DESIGN REVIEW BOARD RECORD OF DECISION

Meeting Date August 22, 2024 **DRB Case No.** PDR-002779-2024
Address 652 Robin Glen Drive
Applicant Suro Barchyan

DESIGN REVIEW STAFF REPORT – HILLSIDE SINGLE FAMILY

PDR-002779-2024

DRAWING
TITLE
Proposed Building
Elevations

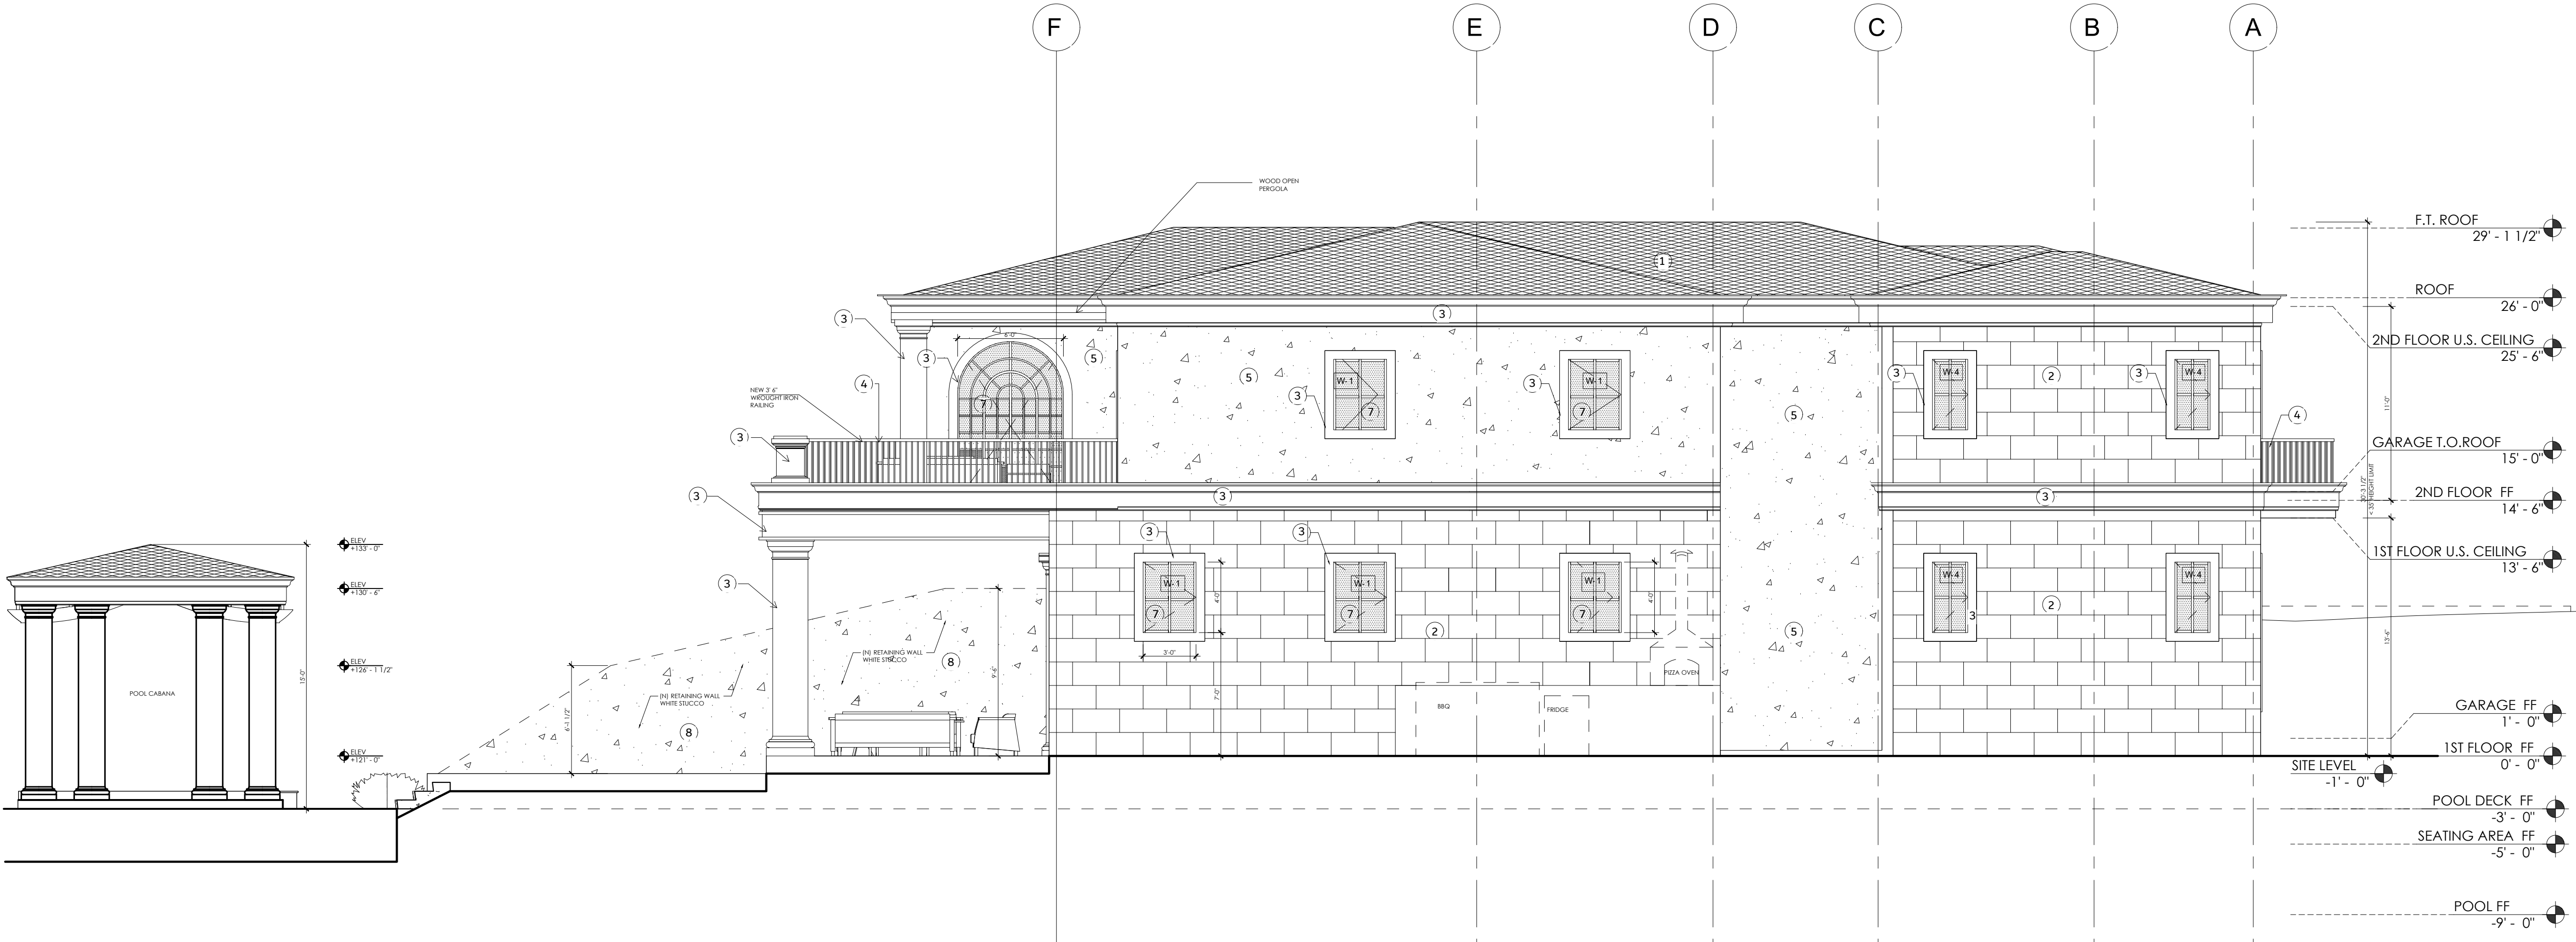
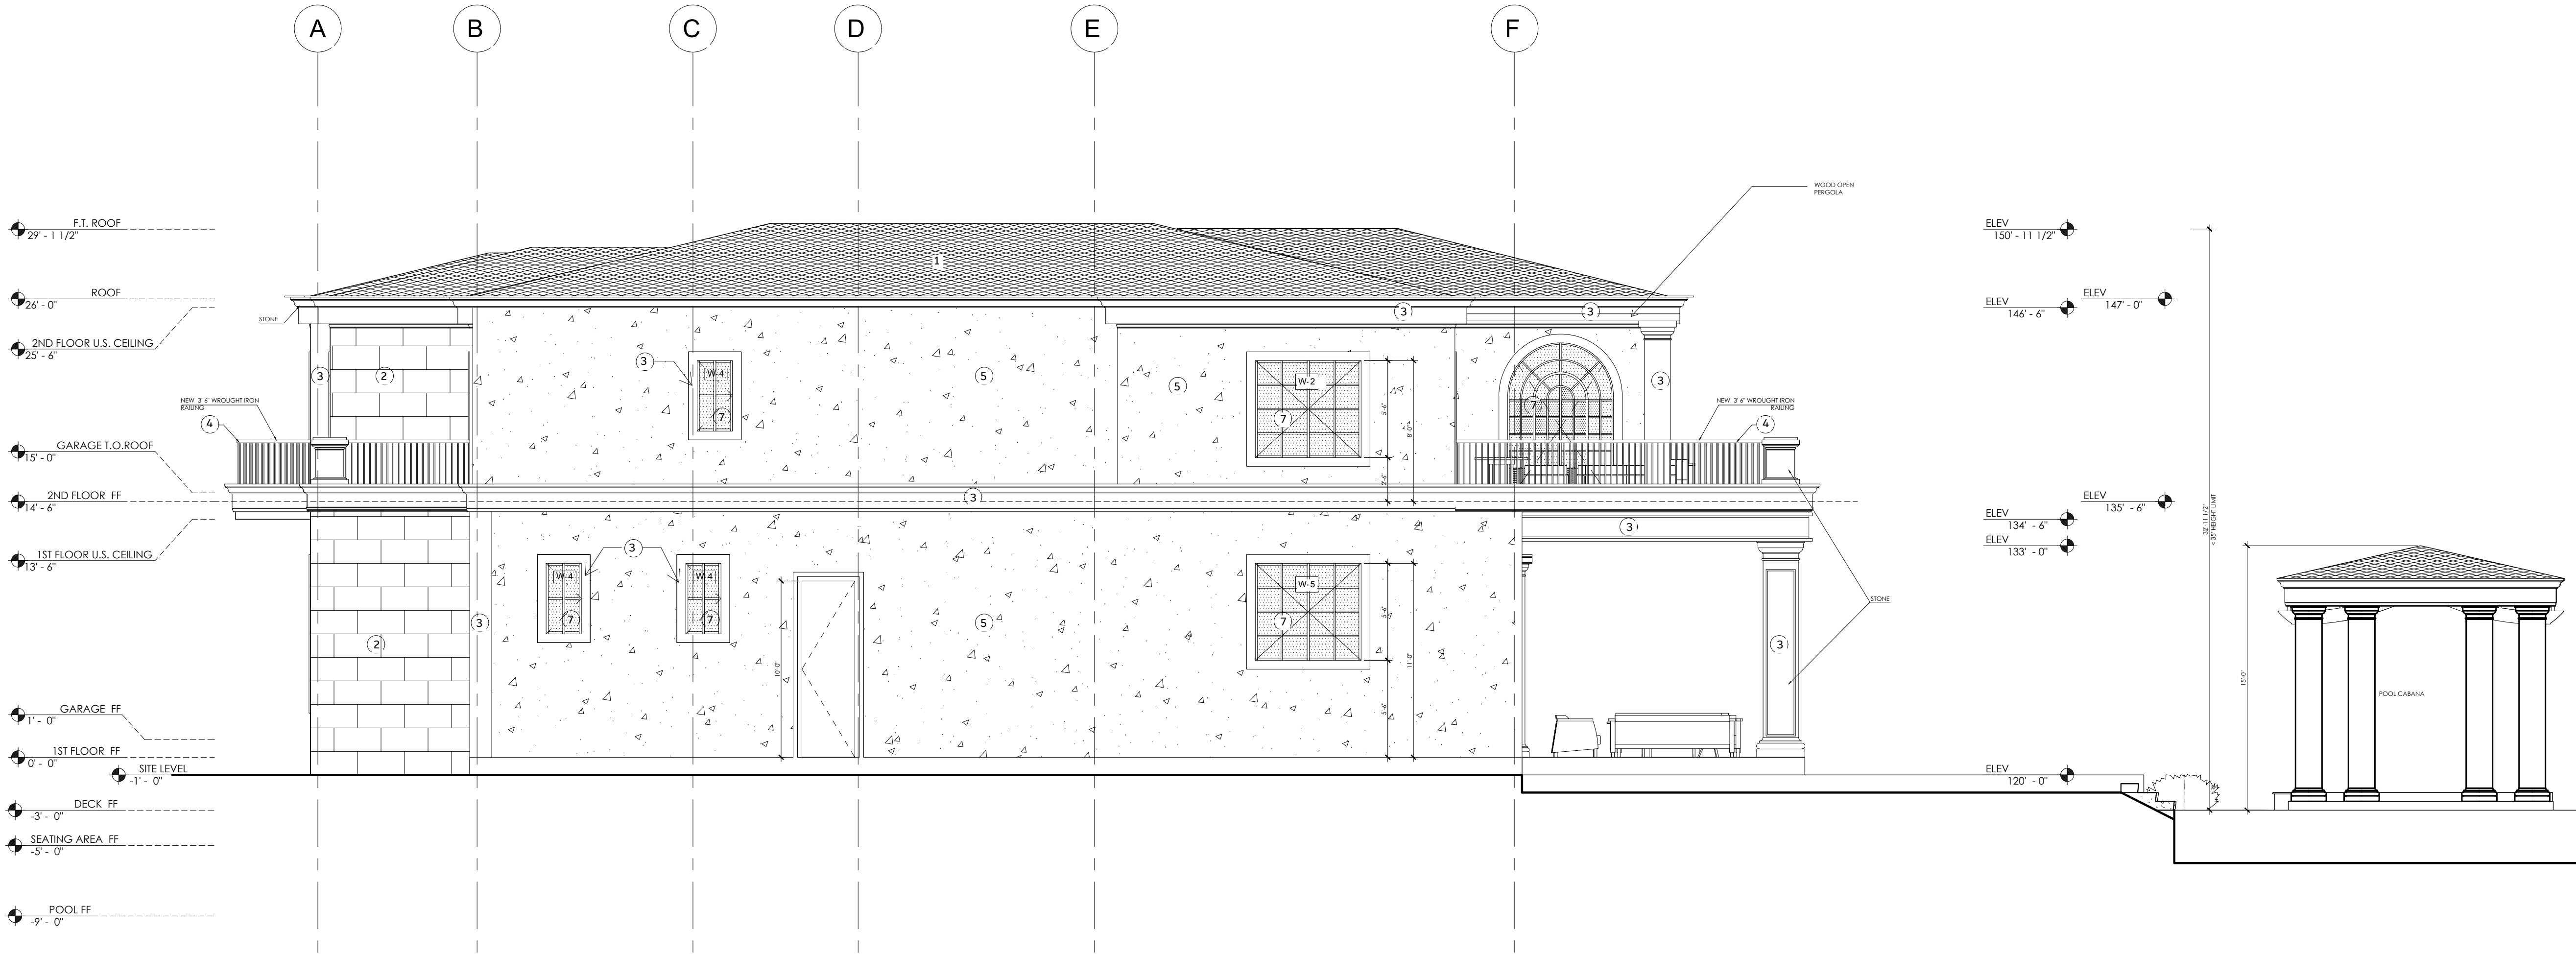
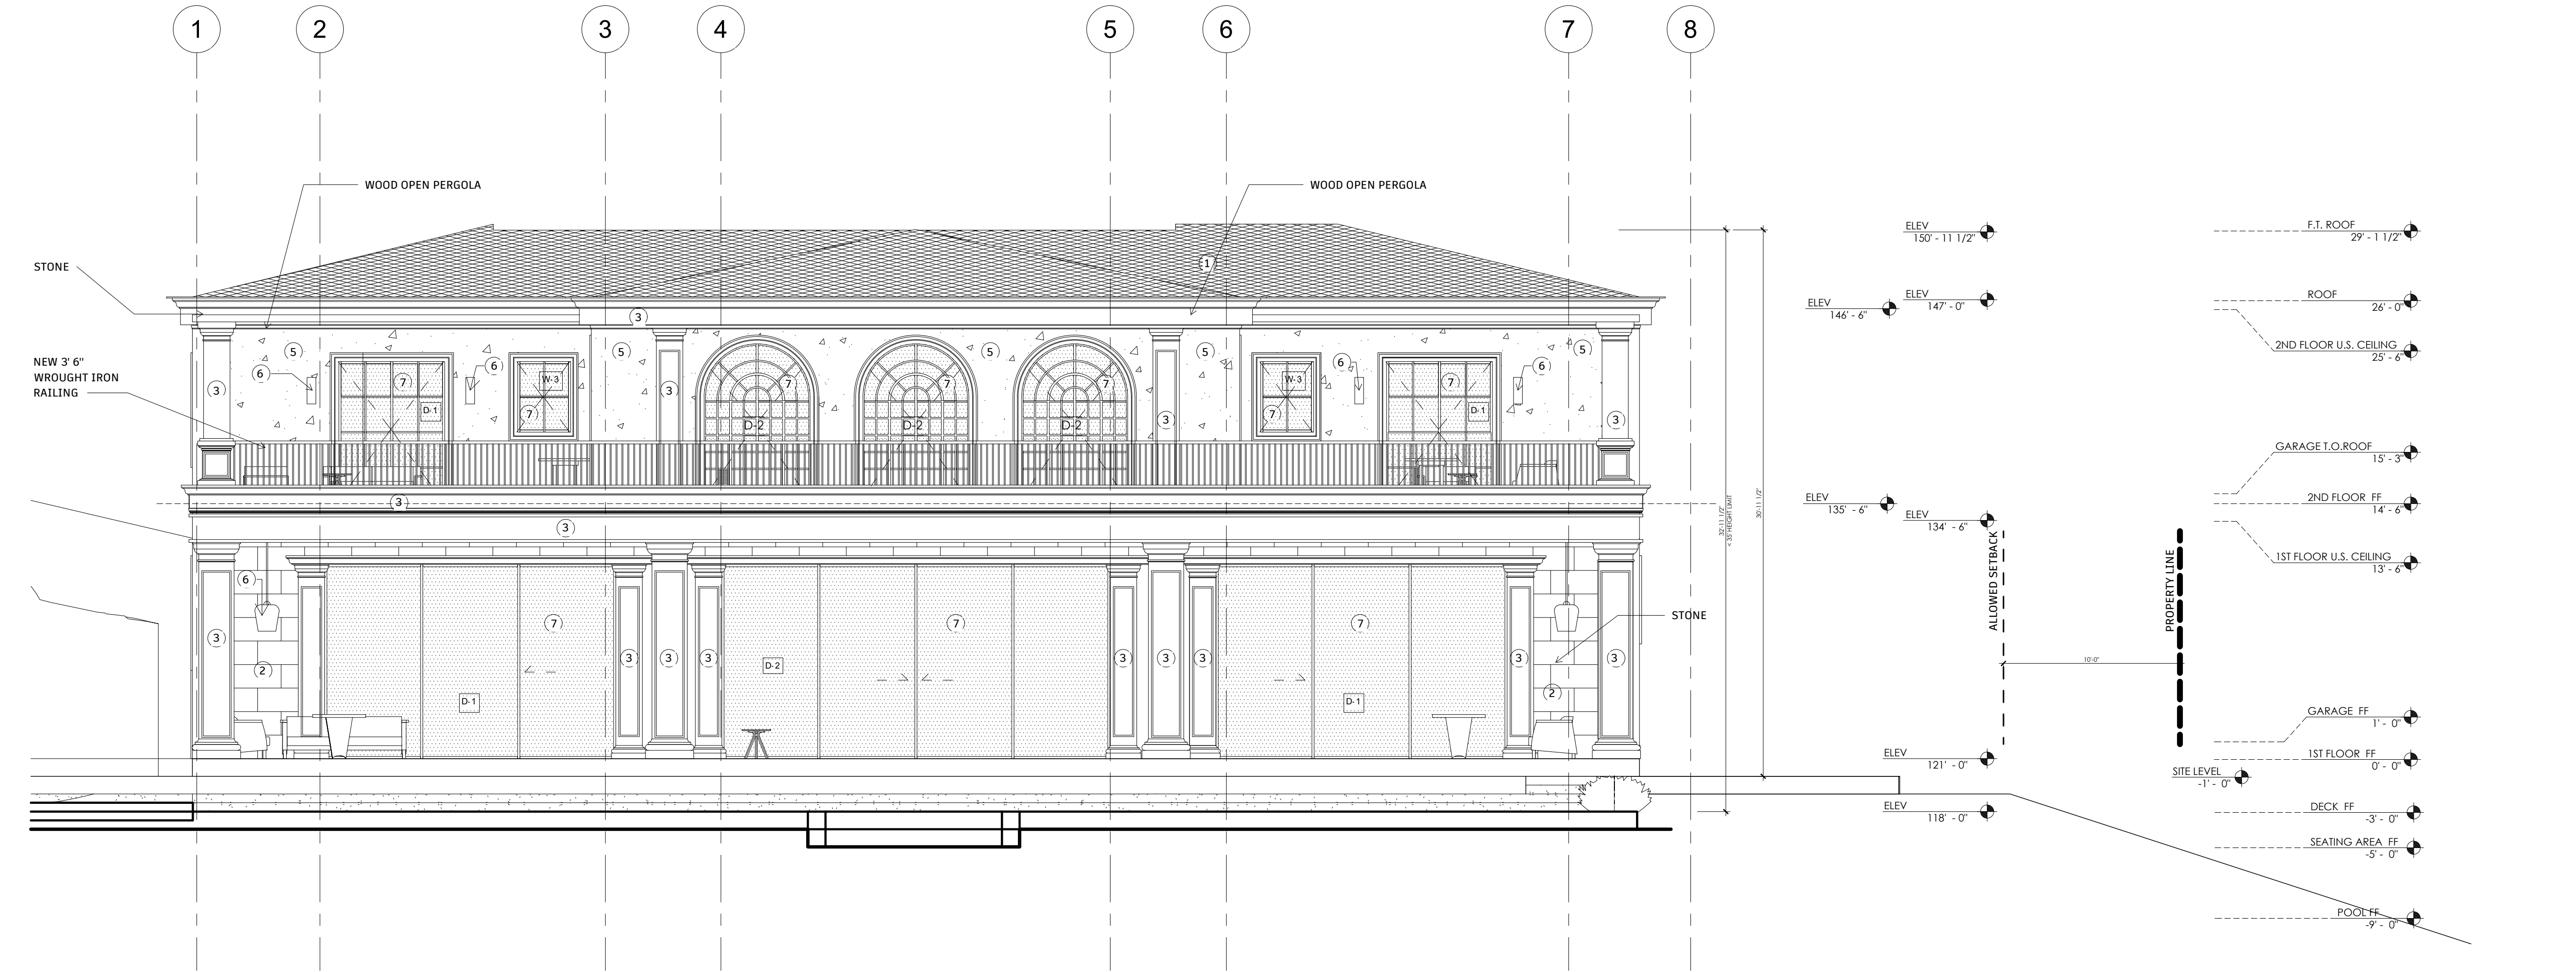
1. Reduce the proposed floor to ceiling height at the first and second floor; and lower the heights of the garage and pool cabana to provide better proportions and avoid the sense of monumentality as well as minimize the visual impact.
2. Redesign the facades that are visible from the street, particularly the east façade, to reduce the boxy appearance and monumentality of the house by stepping back the

second floor to follow the site topography, providing more articulations, using various roof heights and types, and incorporating a variation of materials/colors.

3. Revise the colors of the proposed exterior wall finishes to provide a distinct color palette.
4. Eliminate the balcony next to bedroom 5 (east side) to avoid potential privacy conflicts with the neighboring properties to the east.
5. Relocate the outdoor kitchen (BBQ counter) and HVAC condensers to the west side of the house.
6. Redesign the deck area and retaining walls on the west side to meet the zoning code height restriction.
7. Redesign the proposed retaining wall on the east side of the new house with the project's civil engineer to study the soil condition to avoid potential runoff.
8. Revise the landscape plan to replace the proposed shrubs on the east side of the house with drought-tolerant hedges or trees that will grow tall to provide privacy buffer.
9. Revise the proposed material for the windows to meet Building and Safety code (Title 24) requirements.
